Notice of Allowability

10/736,930

SAMIE ET AL.

EXAMINER'S AMENDMENT

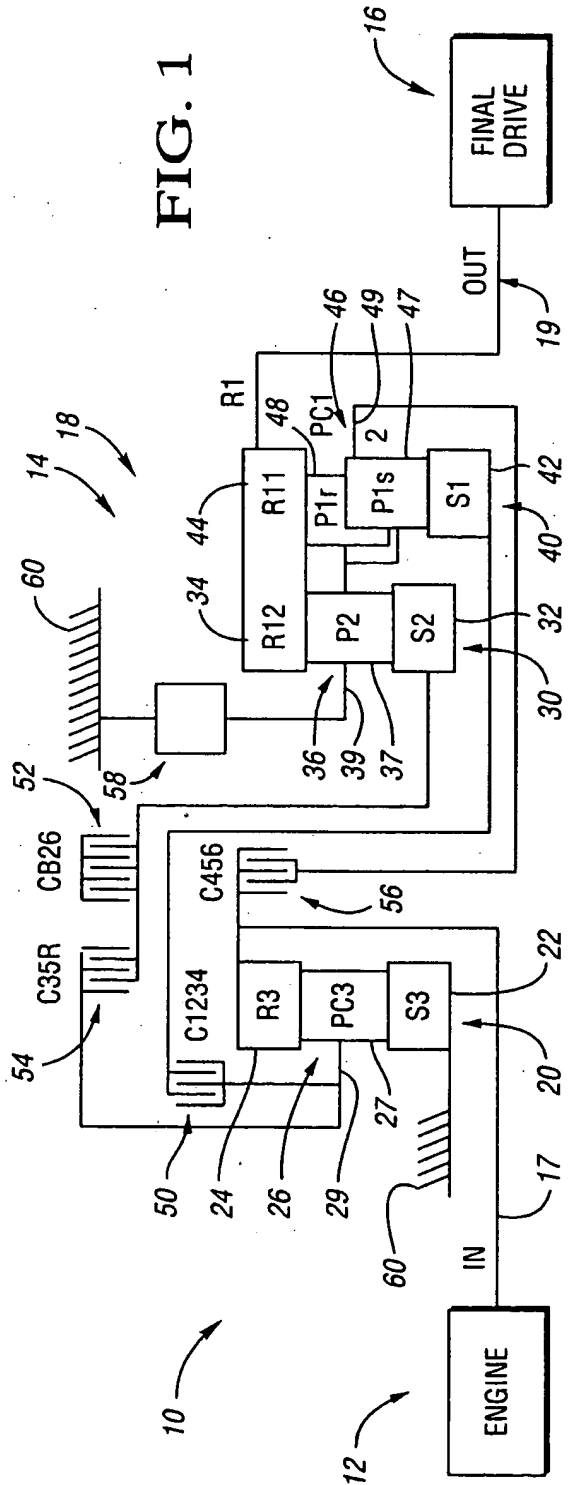
- The following changes to the drawings have been approved by the examiner and agreed upon by applicant:
 - FIG.2, “MECHANICAL DIODE (58)” has been amended as --
SELECTABLE BRAKING ONE-WAY CLUTCH (58)--.

In order to avoid abandonment of the application, applicant must make these above agreed upon drawing changes. See attached FIG.2.
